City of Albuquerque

Re: Mountain Breeze Subdivision Grading and Drainage Plan
Engineer's Stamp dated 12-15-97 (F21/D71)
Certification dated 8-14-00

**RE: *Grading and Drainage Certification Plan for Mountain Breeze Subdivision (F21/D71)
Submitted for Final Plat and Release of Financial Guarantees, Engineer's
Certification Stamp Dated 8/14/00.***

RE: Grading and Drainage Plan for Mountain Breeze Subdivision (F21/D71) Submitted for Preliminary and Final Plat Approval, Engineer's Stamp Dated 10/29/97.

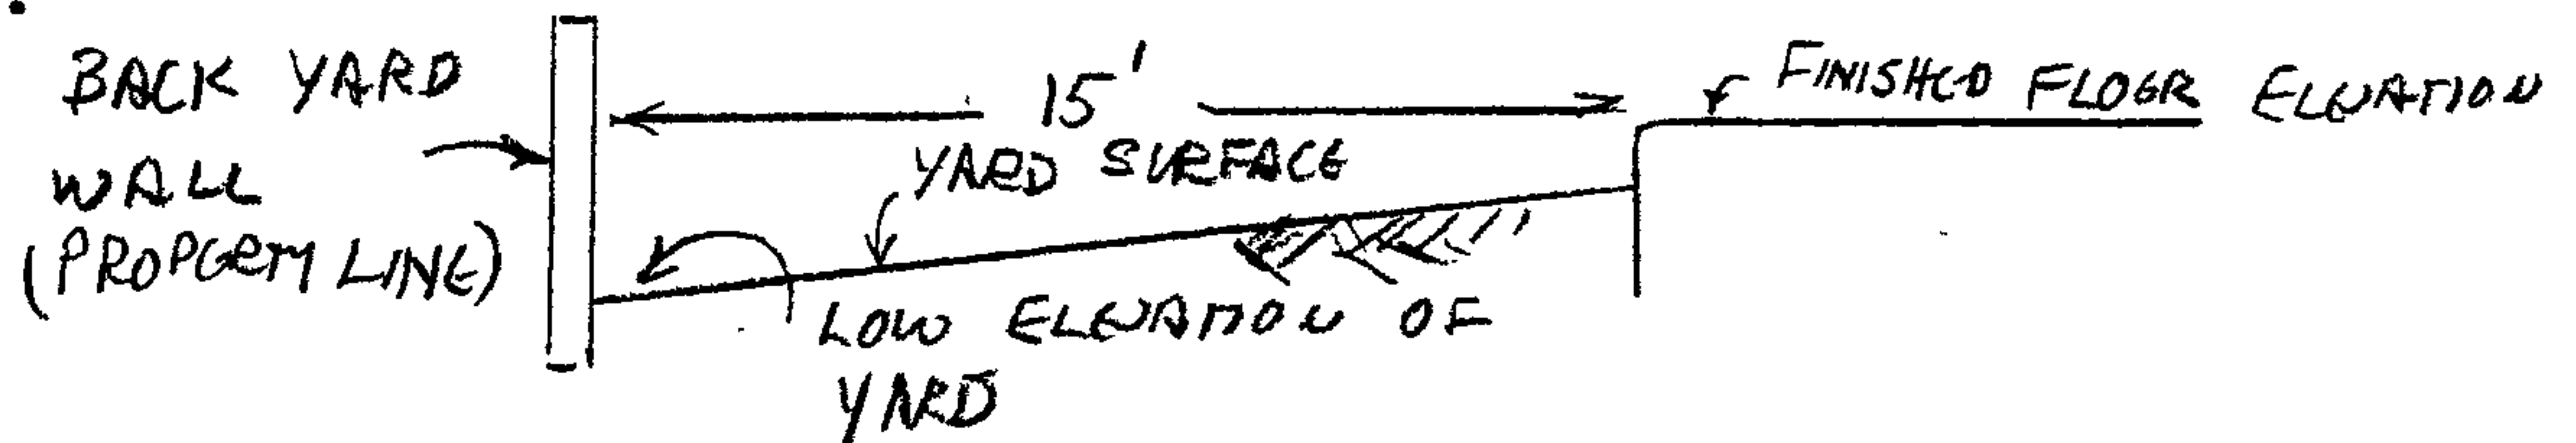
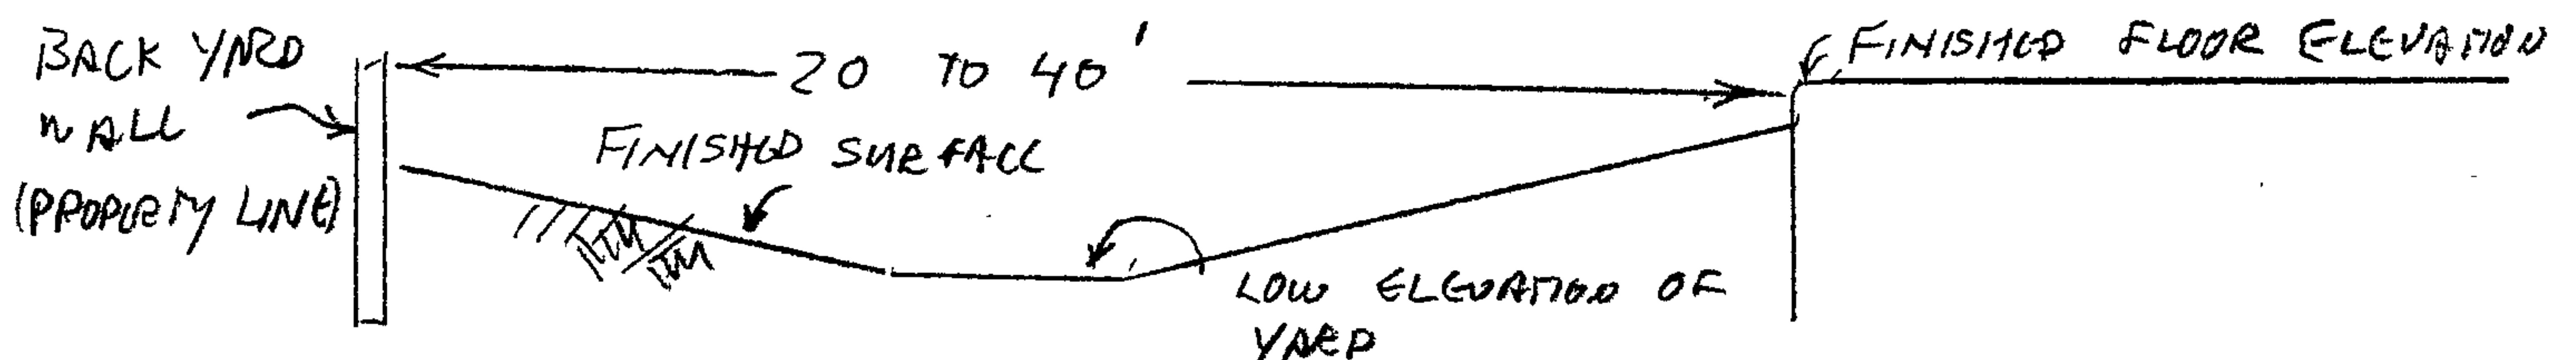
Comment 1. Susan's comment is that grades (elevations?) have been changed by more than 18" within 50' of the perimeter of the subdivision, and, therefore, a public hearing and DRB approval of the changes would be required. I had stated in my letter of August 14, 2000, that the reasons that changes were acceptable were,

Perhaps these two sketches will illustrate what the difference is between the planned grading concept, and the as-constructed grading.

The planned grading concept shows the house being built to or near the maximum setback permitted, which is 15 feet. This grading concept shows a slope away from the finished building so that no ponding will occur adjacent to the foundation. The swale along the back property line was added at the direction of the City of Albuquerque because at the time of approval of the Grading and Drainage Plan the City would not approve the back yard ponding for direct precipitation.

The as-constructed grading shows a much larger back yard, which permits varying elevations within the yard, and still provides for the required slope away from the finished building. The yard are also large enough to permit the necessary ponding of the direct precipitation within the yard area. At this time the builder is using an earth berm and fence along the north-south common property lines to contain the back yard precipitation. The back yards do not receive significant roof runoff, perhaps from a porch or over-hang.

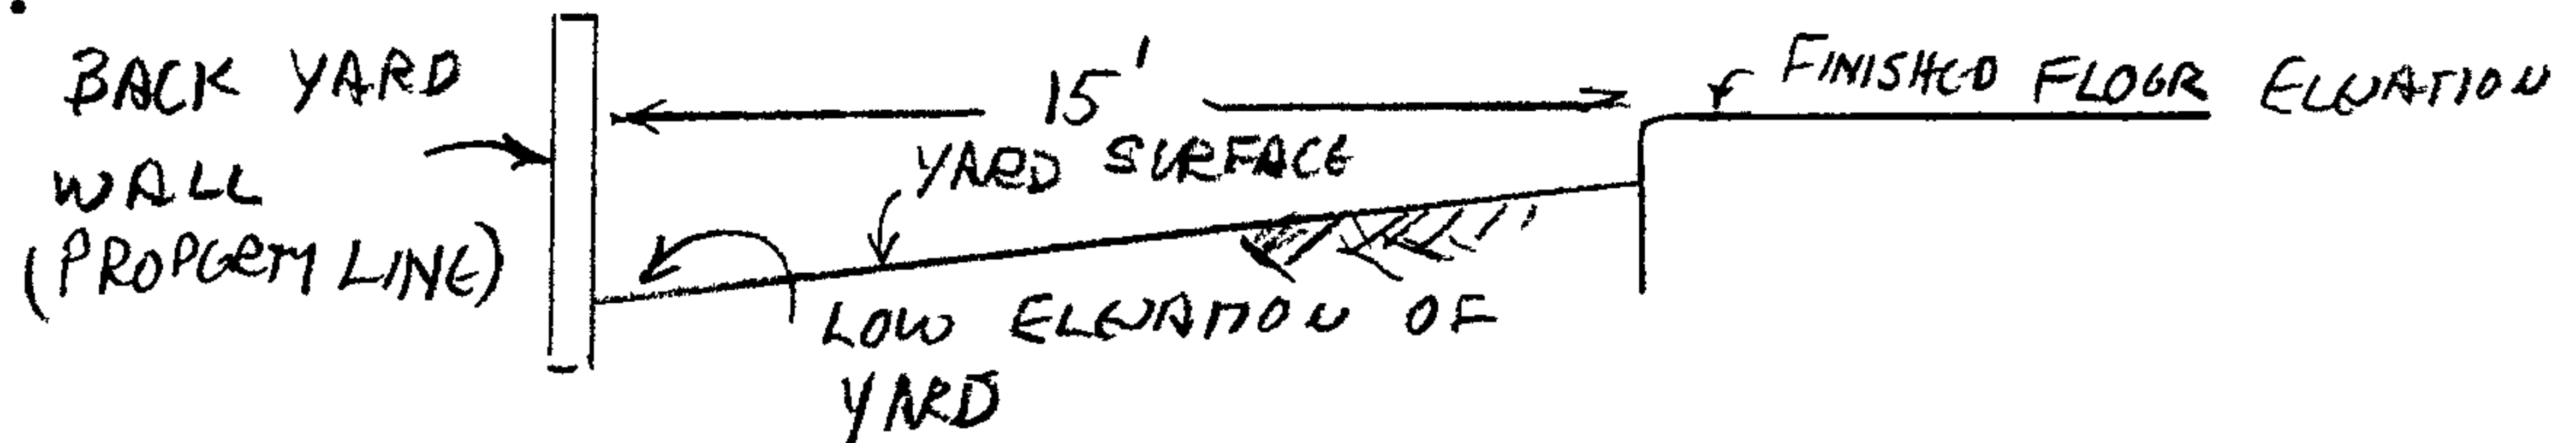
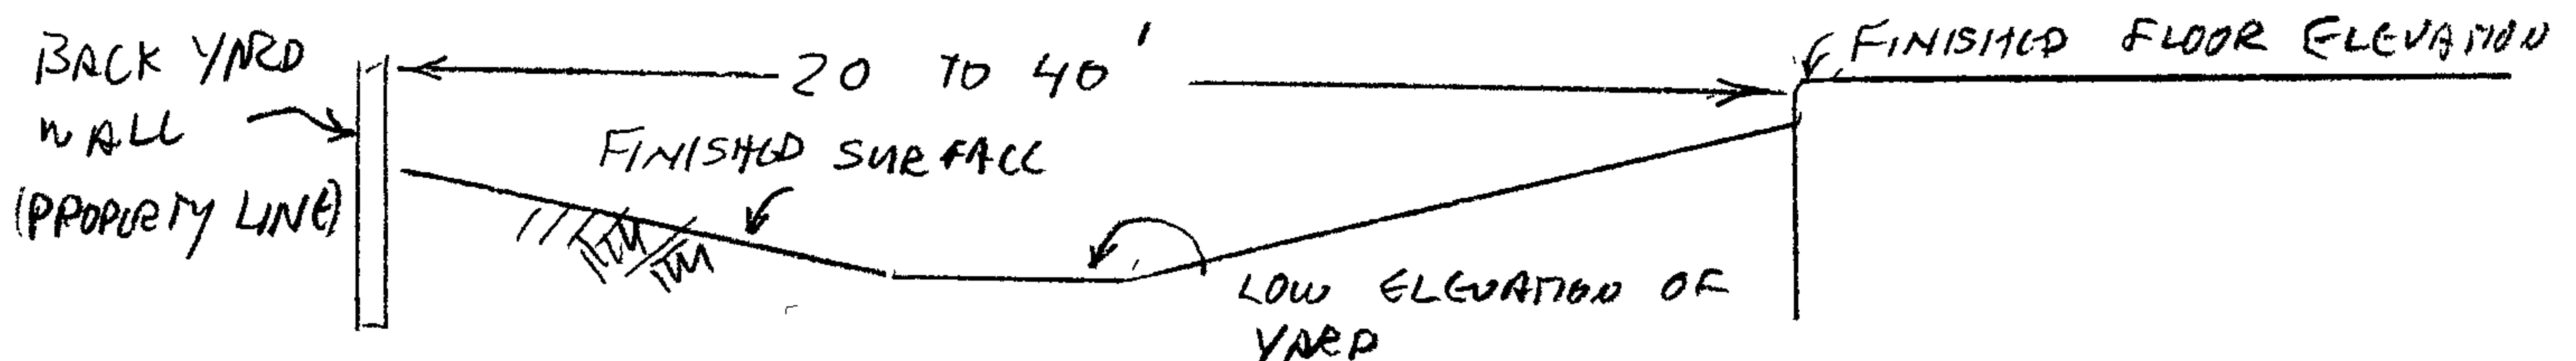
Comment 1. Susan's comment is that grades (elevations?) have been changed by more than 18" within 50' of the perimeter of the subdivision, and, therefore, a public hearing and DRB approval of the changes would be required. I had stated in my letter of August 14, 2000, that the reasons that changes were acceptable were,

Perhaps these two sketches will illustrate what the difference is between the planned grading concept, and the as-constructed grading.

The planned grading concept shows the house being built to or near the maximum setback permitted, which is 15 feet. This grading concept shows a slope away from the finished building so that no ponding will occur adjacent to the foundation. The swale along the back property line was added at the direction of the City of Albuquerque because at the time of approval of the Grading and Drainage Plan the City would not approve the back yard ponding for direct precipitation.

The as-constructed grading shows a much larger back yard, which permits varying elevations within the yard, and still provides for the required slope away from the finished building. The yard are also large enough to permit the necessary ponding of the direct precipitation within the yard area. At this time the builder is using an earth berm and fence along the north-south common property lines to contain the back yard precipitation. The back yards do not receive significant roof runoff, perhaps from a porch or over-hang.
